## CCPS RFP#25-04 – NORTH EAST MIDDLE/HIGH SCHOOL REPLACEMENT PROJECT

### ADDENDUM #7

**This addendum is to provide the pre-bid agenda and attendance list and issued revisions to the contract documents as noted below.** Proposers and related parties will be responsible for reading and understanding all documents, the scope of work, addenda and all related solicitation documents issued. These documents will become attached to and part of the solicitation and award of bid contract.

1. **ASIs 01 and 02**
2. **PR 01**
3. **CLOSED RFIs 001- 0027, 029-031, 034. (open RFIs are excluded)**

B18 TYP. FOUNDATION DETAIL - CW SILL  
3/8" = 1'-0"

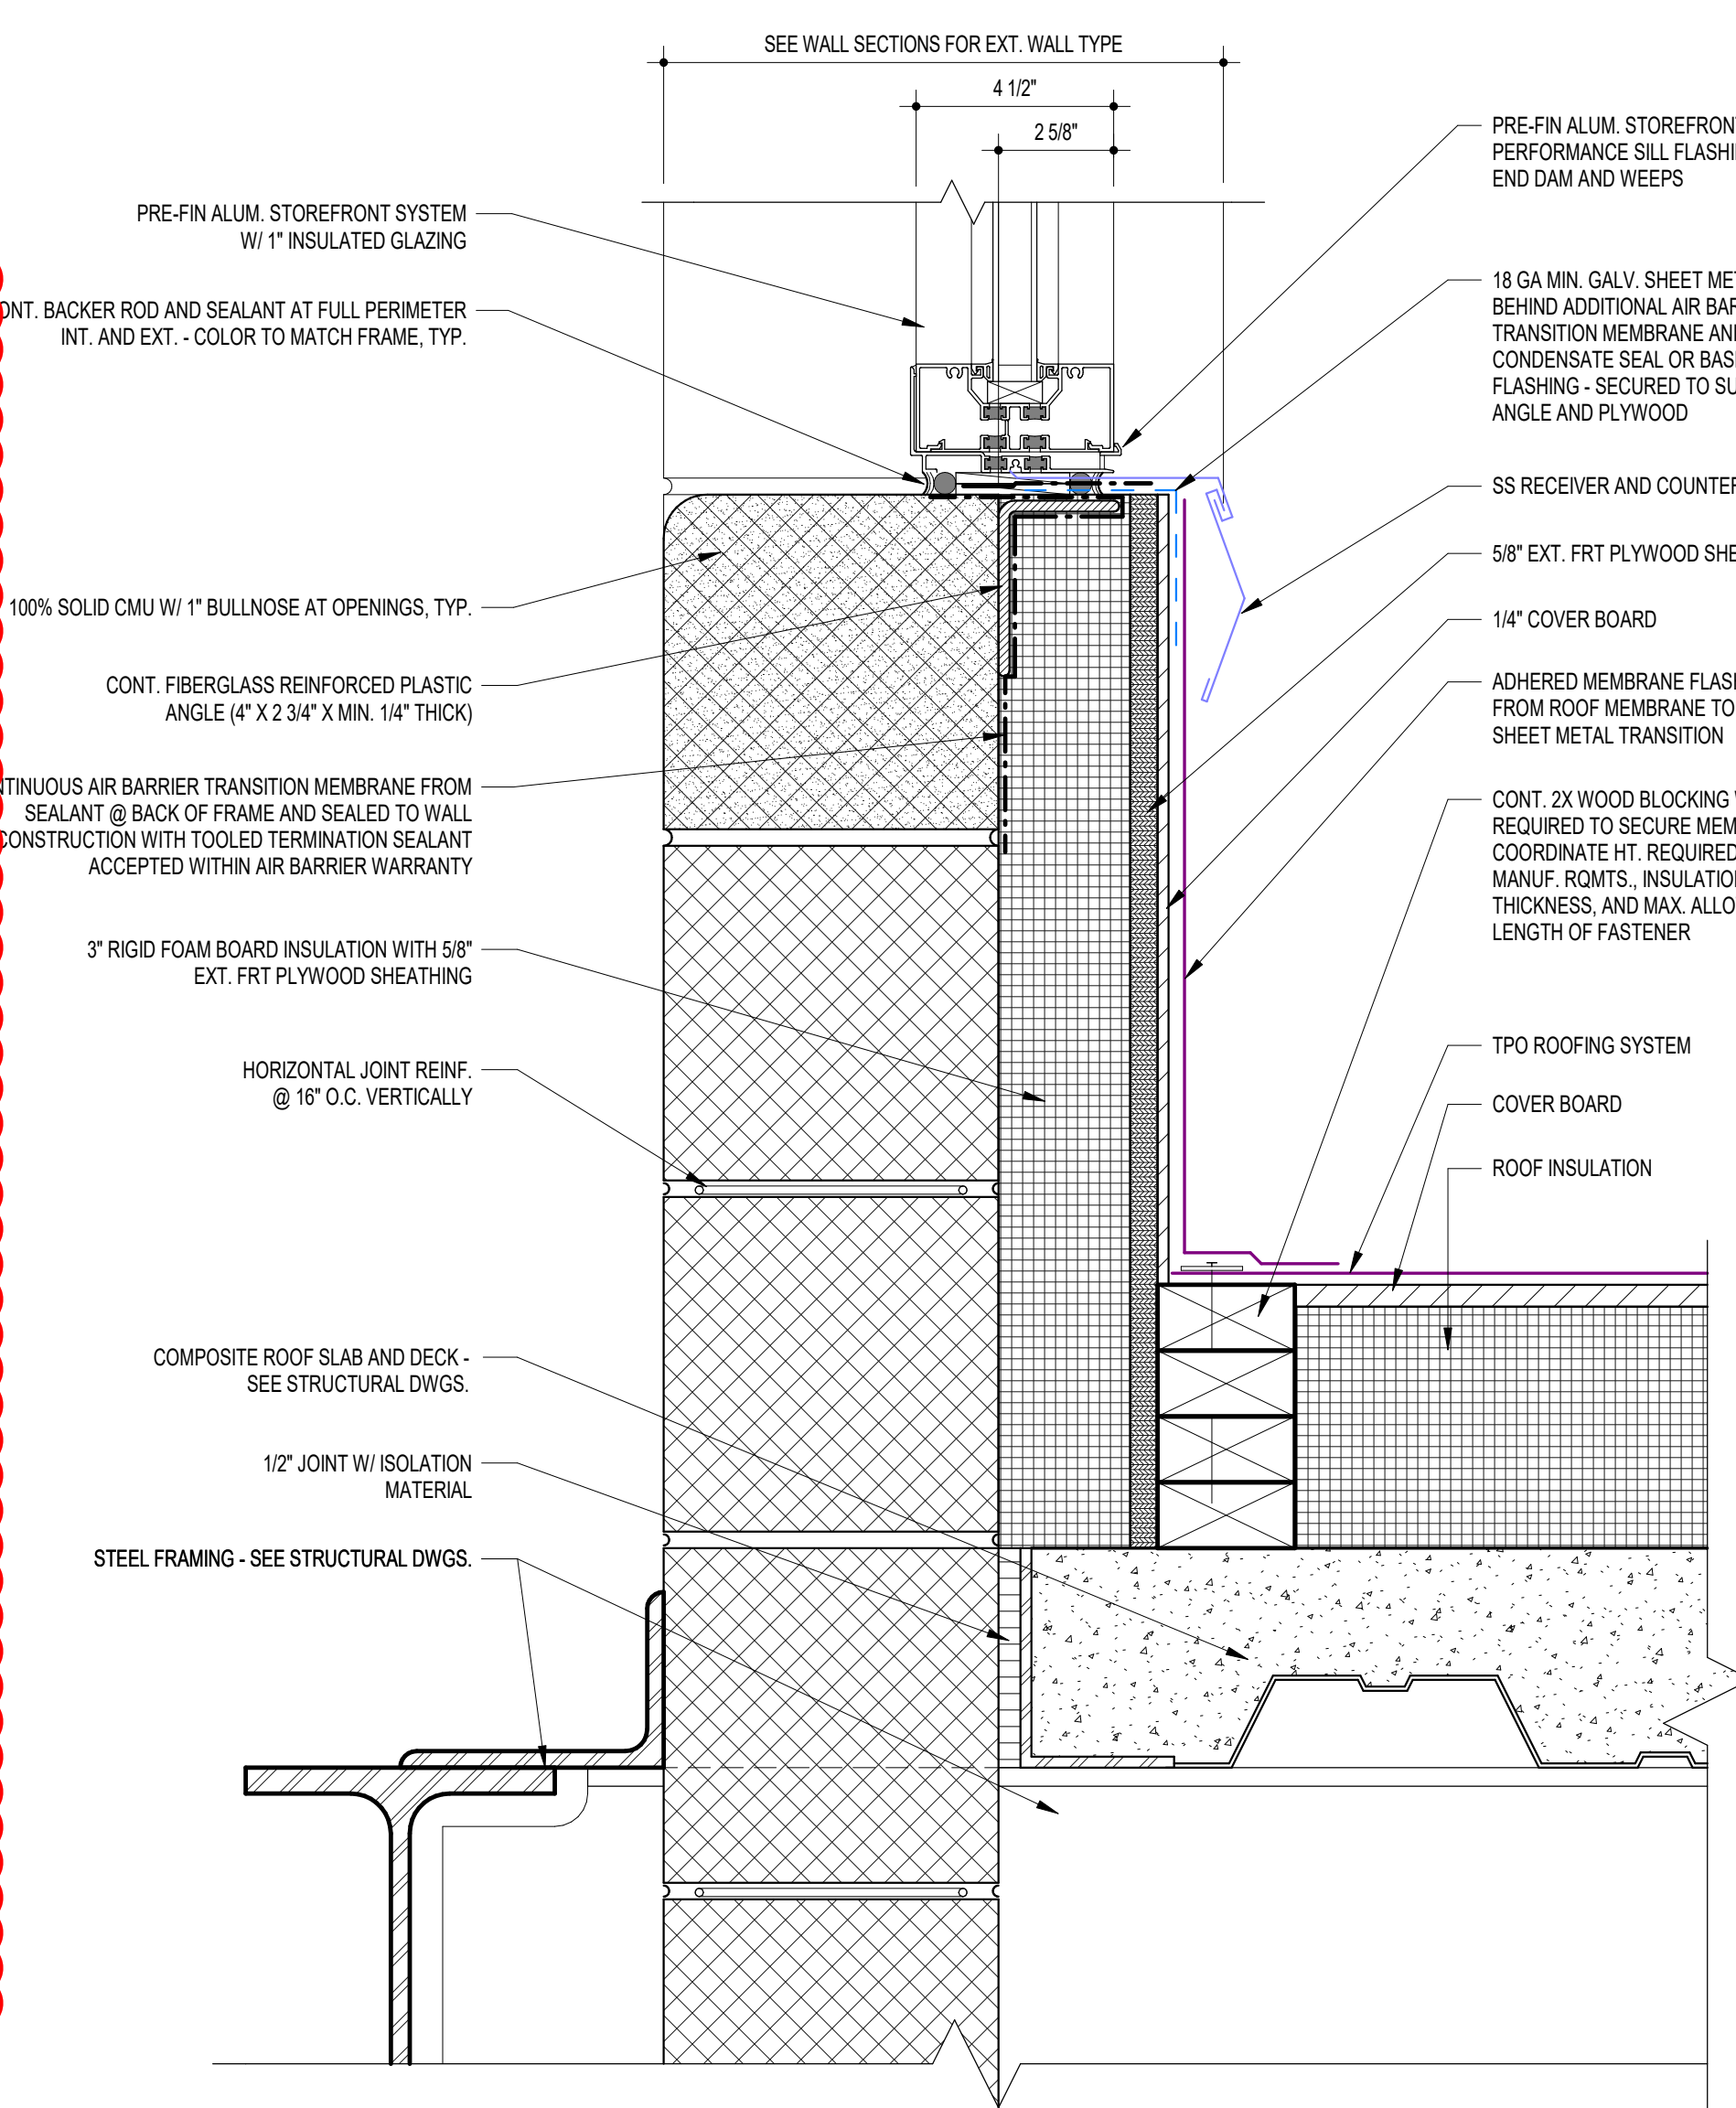
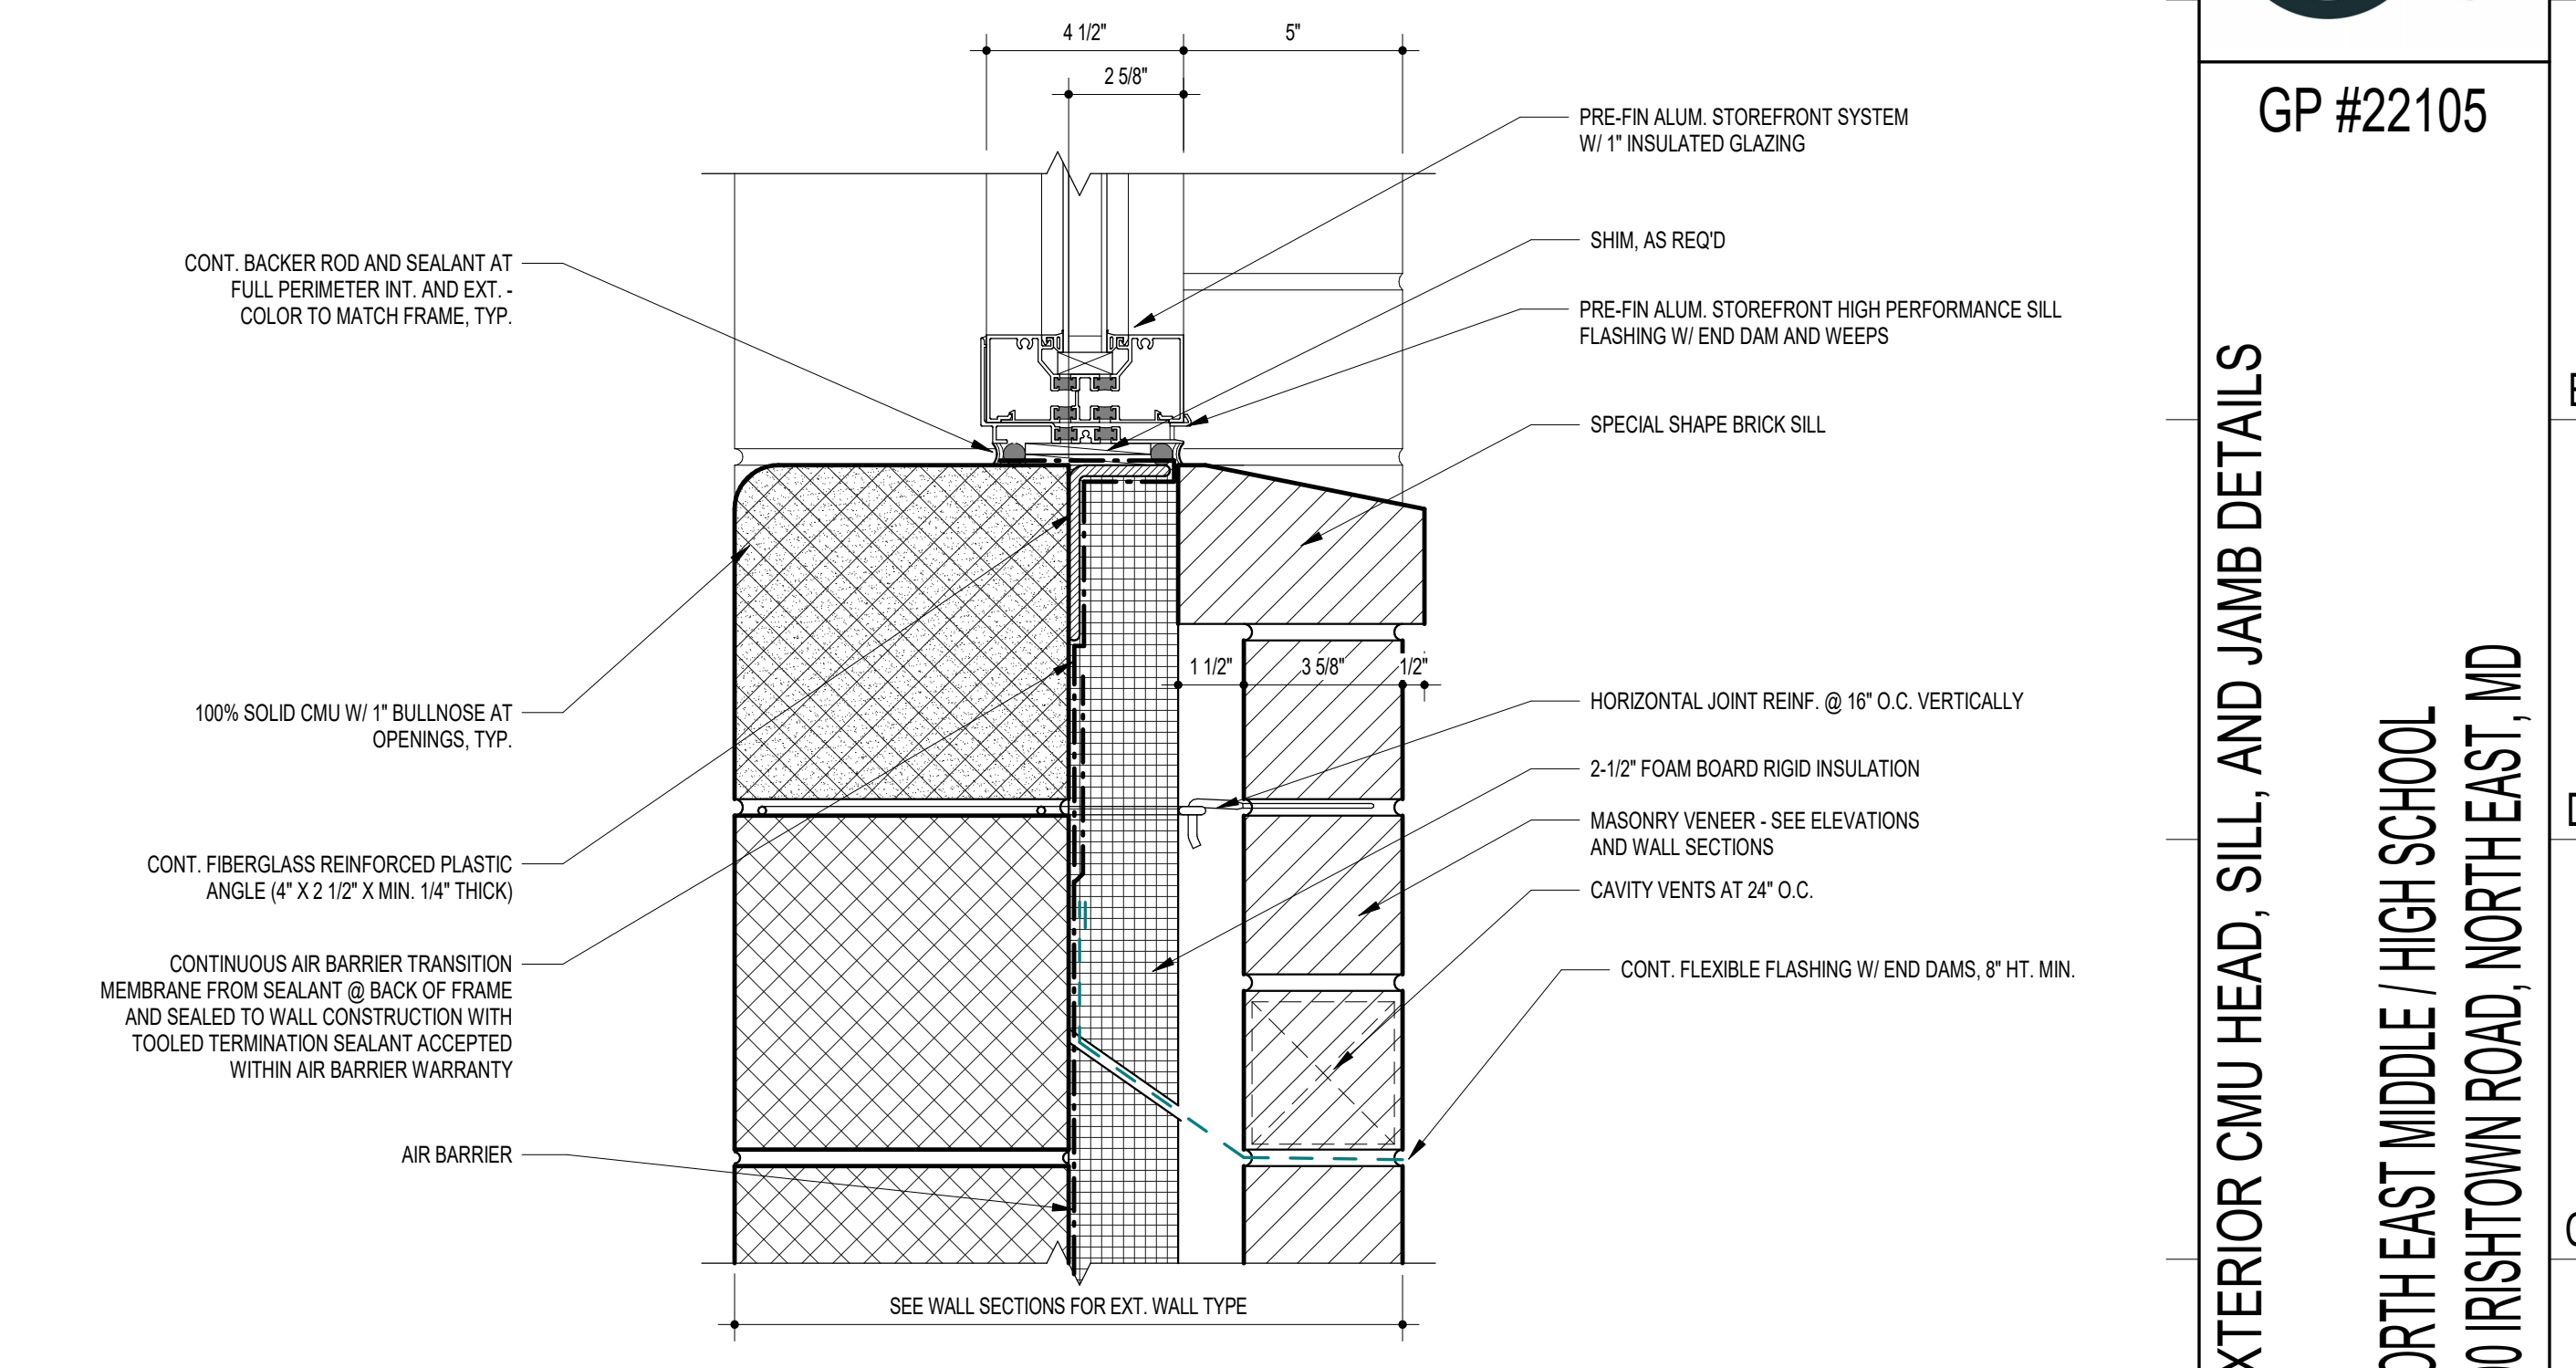
- Typical fenestration details on sheet A422 call for "sealant tape between drip plate and steel lintel," however no product is specified in section 042000. Drip plate will be sealed to steel lintels with the same sealant/mastic used to lap seams in the flashing. Please confirm this meets the requirement and additional sealant tape is not required.

- Details B18 & J12/A422 (and other similar) show "SS Drip Plate Flashing W/ Hemmed Edge" running from face of brick, through the cavity (with solid grout or steel below) and turning up the substrate with continuous flexible flashing on top. However, other typical through wall flashing details on sheets A422 & 423 only show the continuous flexible flashing spanning the cavity (without support from grout below). Please confirm the drip edge in details B18 & J12/A422 can be reduced to 3" deep as long as flexible through-wall flashing is fully supported.

- Several details on sheets A422-427 do not always show SS drip plates at face of brick veneer, but spec 042000 2.7 B 3 calls for a drip edge where "flashing is partly exposed and is indicated to terminate at the wall face." Please confirm SS drip edge shall be used at all masonry through wall flashing locations unless a roofer's reglet (or sim.) is required.

1. The preformed silicone extrusion is required at joints where there is a change in substrate, CMU expansion joints, gyp sheathing vertical expansion joints, masonry expansion joints between CMU and concrete, etc. See details on sheet A427.
2. See attached basis-of-design product from York Flashings - UniverSeal US-100 Liquid Tape, or approved equal.
3. Both the Weep-Armor and Weep-Net are required. The Weep-Armor is installed first (see attached cut sheet) and the Weep-Net rests on top of the Weep-Armor.
4. No. Install drip edge per details.
5. Paragraph 2.7.B begins with "UNLESS OTHERWISE INDICATED...". Install the flexible flashing as detailed on the contract documents.
